City of Newton, Massachusetts
Department of Planning and Development
1000 Commonwealth Avenue Newton, Massachusetts 02459

STAFF MEMORANDUM

Meeting Date: **Wednesday, July 14, 2021**
DATE: July 9, 2021
TO: Urban Design Commission
FROM: Shubee Sikka, Urban Designer
SUBJECT: **Additional Review Information**

1. 49 Osborne Path Fence Appeal

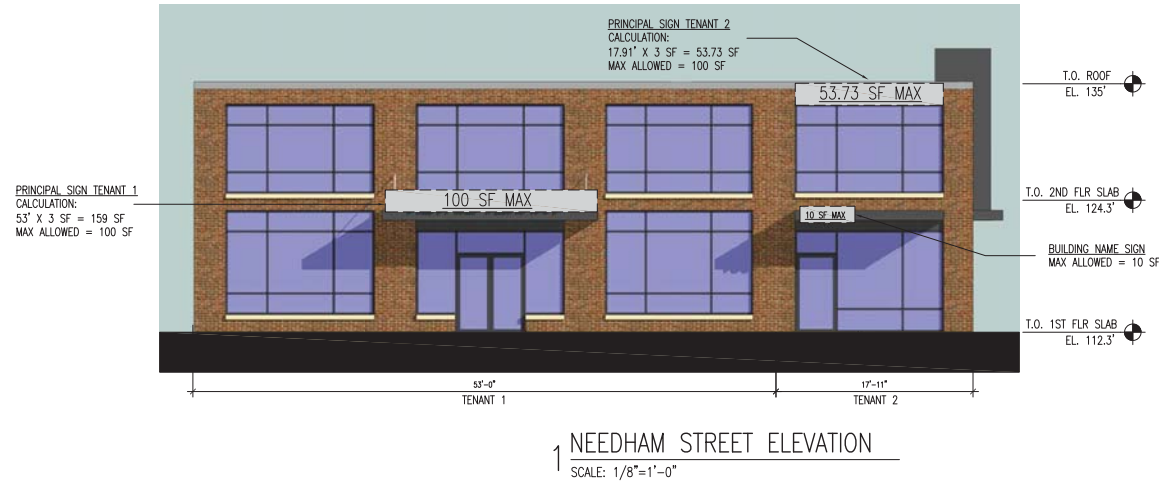
Note from staff about distance from the property line: It appears that the fence is more than 6 inches away from the property line. There was a fence permit issued in 2010 for the existing fence (4-ft solid with 2-ft lattice). Staff has requested the applicant to determine the correct distance of the fence from the property line.

The proposed fence set at 6 inches from the front property line appears to be not consistent with the fence criteria outlined in §5-30(d)(1) of the Newton Code of Ordinances.

The applicant is seeking an exception to allow 6 feet tall solid white vinyl fence set at 6 inches from the front property line for a length of 150 feet. The applicant's stated reasons for seeking this exception are "We would like to increase privacy and security along a walking path (abutting elementary school and playground) to screen residential pool. Replacing existing fence which is 6' – 4' solid with 2' lattice".

STAFF RECOMMENDATION: Staff will provide a recommendation at the meeting after hearing back from the applicant about the distance of the fence from the property line.
